文件编号 Document No.	ESP-07-2-007-03	文件名称 Document Name	产品/工艺变更通知 Product/Process Change Notice (PCN)
文件版本 Document Version	1.4	保存期限 Retention Period	5 年 5 years

基于 ESP32-S2 芯片的 ESP32-S2 系列产品的芯片版本升级
Upgrade Chip Revision of ESP32-S2 Series Products Based on ESP32-S2

PCN 编号 PCN No.	PCN20230702	提出日期 Issue Date of PCN	2023/07/28
变更日期 Proposed Date of Change	2023/09/28	预计变更后产品首次出货日期 Proposed Date of First Shipment After Change	2023/11/01
PCN 类型 / PCN Category	☒ 客户需要批准/ Customer Approval Required ☐ 客户通知/ Customer Notification

6. 变更前后产品处理/ How to Deal with Products

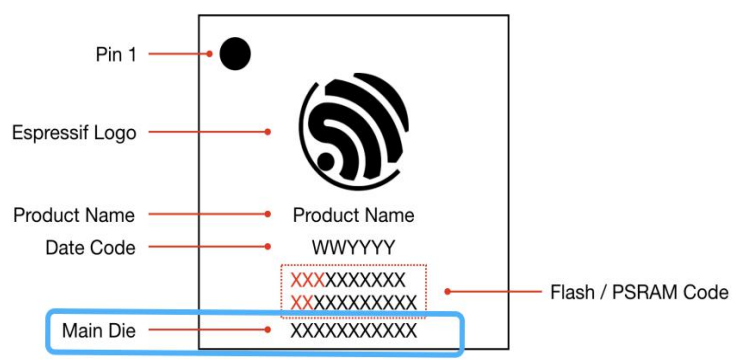
FIFO
